Product Change Notification / JAON-18YCSW720

CCB 5014.003 Initial Notice: Qualification of a new die size (1.932x1.860mm) for Die #1 of selected Microsemi LE9653AQC, LE9653AQCT, LE9621AQC, LE9643AQC, LE9621AQCT, and LE9643AQCT catalog part numbers (CPN) available in 36L VQFN (4x6x1mm) package assembled at ASEM assembly site.

PCN #: JAON-18YCSW720

CCB 5014.003
Pre and Post Change Summary
PCN#: JAON-18YCSW720

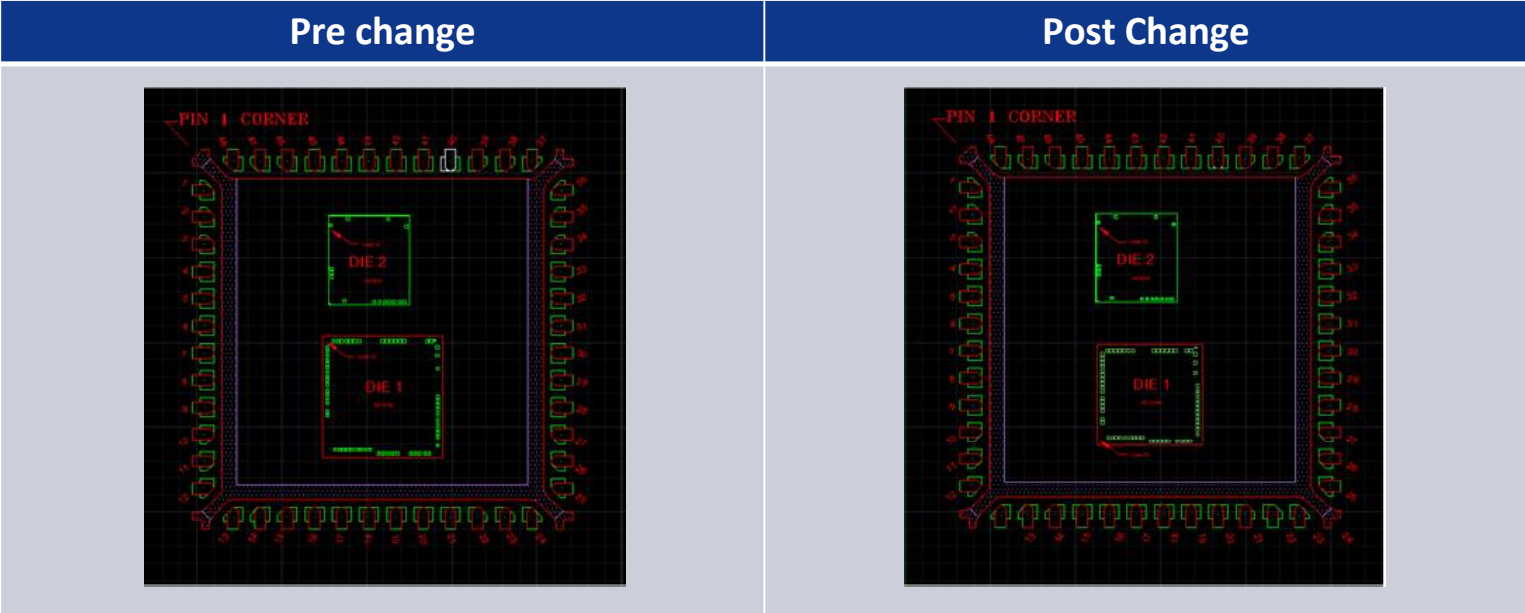
Description of Change:Qualification of a new die size (1.932x1.860mm) for Die #1 of selected Microsemi LE9653AQC, LE9653AQCT, LE9621AQC, LE9643AQC, LE9621AQCT, and LE9643AQCT catalog part numbers (CPN) available in 36L VQFN (4x6x1mm) package assembled at ASEM assembly site.

Pre and post change comparison
